INQUIRY INTO DEVELOPMENT OF THE TRANSPORT ORIENTED DEVELOPMENT PROGRAM

Organisation: Central Coast Council

Submission on Transport Orientated Development (TOD) SEPP Program

Attachment 1 – Central Coast Council Feedback on TOD SEPP

Application to Gosford Centre of TOD SEPP provisions (5.6Ha approx.) where height is 13m and FSR 1.5:1.

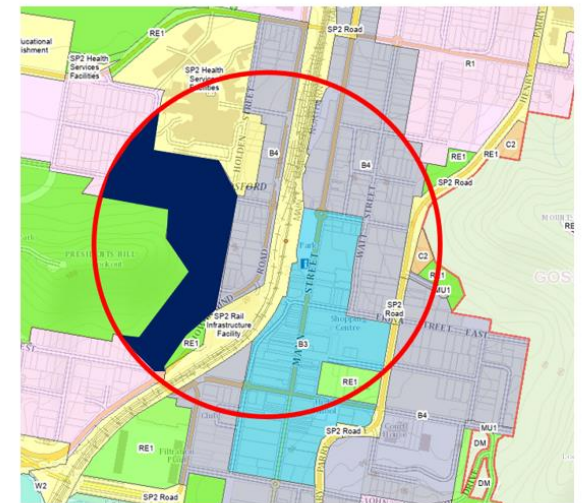
Figures 1 and 2 identify housing emerging on sites to be included in the TOD SEPP. It will therefore be a redundant instrument and it is recommended that Gosford Centre be removed from the TOD SEPP.

The Gosford city centre lands have recently been redeveloped by bonus provisions (30% height and FSR) enabled by the former Gosford LEP 2014 and currently support high density development (see Figures 1 and 2). It is our estimation that less than 50% of the land area nominated by the TOD SEPP provisions (5.6Ha including local roads) would be available for development, without any assessment of the viability or constraints of the land.

Land application

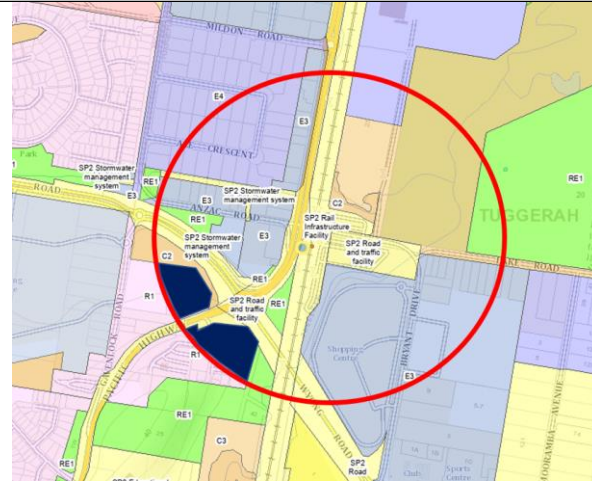
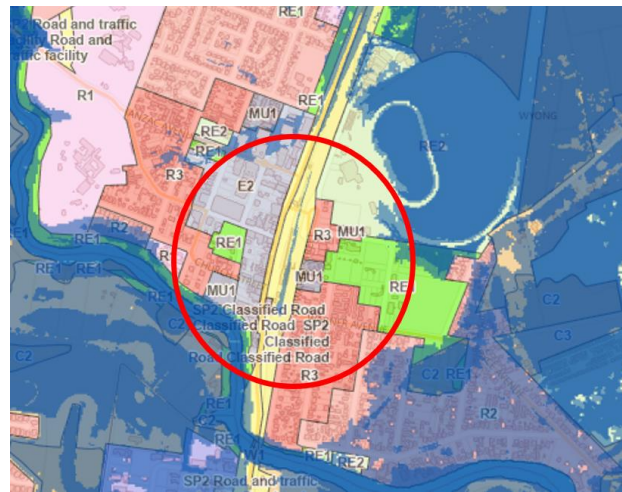
Note the zoning in this location prevents greater application of the provisions in this centre, and the R1 site to the north of the site between the Pacific Highway and Gavenlock Road contains:

- Swamp Oak Floodplain Forest of the New South Wales North Coast, Sydney Basin, and South East Corner Bioregions – listed as an endangered ecological community under the BC Act
- Swamp Sclerophyll Forest on Coastal Floodplains of the New South Wales North Coast, Sydney Basin, and South East Corner Bioregions – listed as a endangered ecological community under the BC Act
- *Melaleuca biconvexa* – listed as vulnerable under the BC Act and EPBC Act

The site to the south of the Pacific Highway represents 1.7Ha of land that is already developed with dwellings which would make redevelopment difficult.
